**Environment Agency
Sustainable Places – Planning**

Re: Ref WX/2025/139447/01-L01 Planning ref: PL/2025/07023

Thank you for your letter dated 5 December 2025, setting out the Environment Agency's objection to the above application on the grounds that the originally submitted Flood Risk Assessment (FRA) did not adequately assess the impacts of the proposed flood gates and kerbing on flood risk to adjacent and downstream areas.

Figure 1- Baseline Maximum Water Levels 1 in 100-year Return Period plus 26% Climate Change Allowance

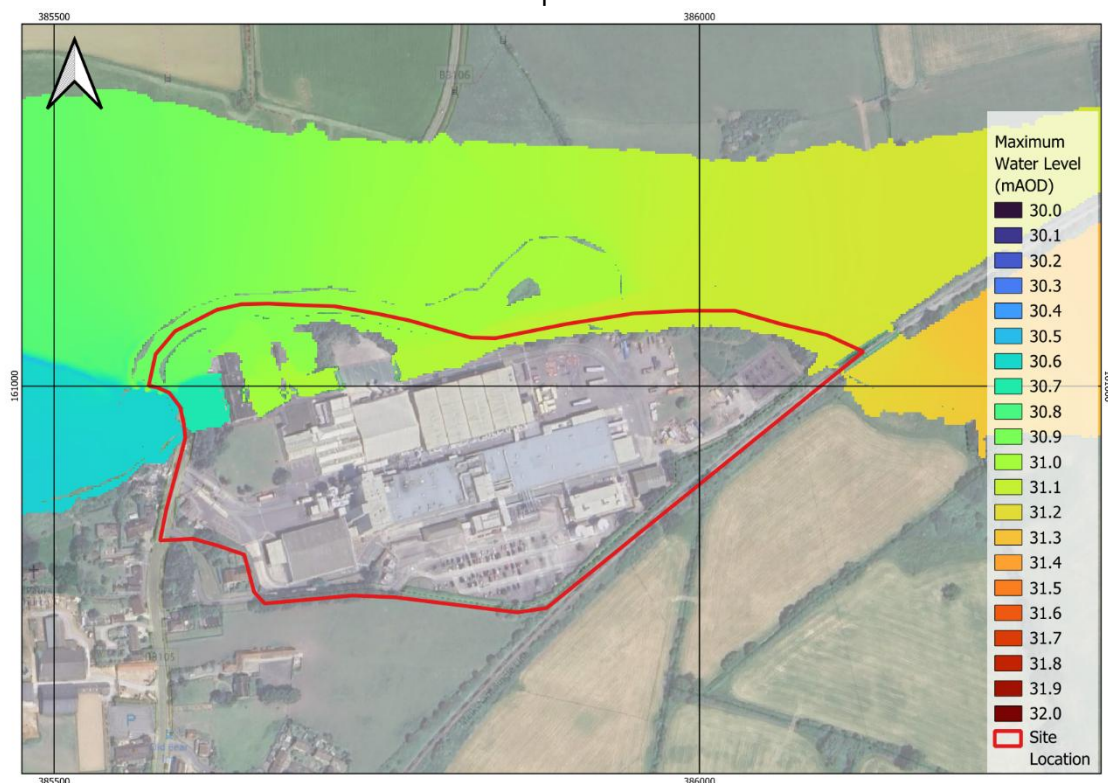
The flood extents do not interact with the resilience measures for the return periods including the design event of 1 in 100 years return period plus 26% climate change allowance.

This is shown in the figures below. Figure 1 shows the maximum flood extents for the 1 in 100-year Return Period plus 26% Climate Change Allowance event for the existing conditions in the site. Figure 2 shows how the flood resilience measures are placed in relation to these flood extents.

The proposed measures do not interact with flood flows during the Design Flood Event and therefore do not impede flood conveyance. Post-development modelling is not required and would show no change to flood extents or levels, as the defences remain dry and result in no disbenefit.
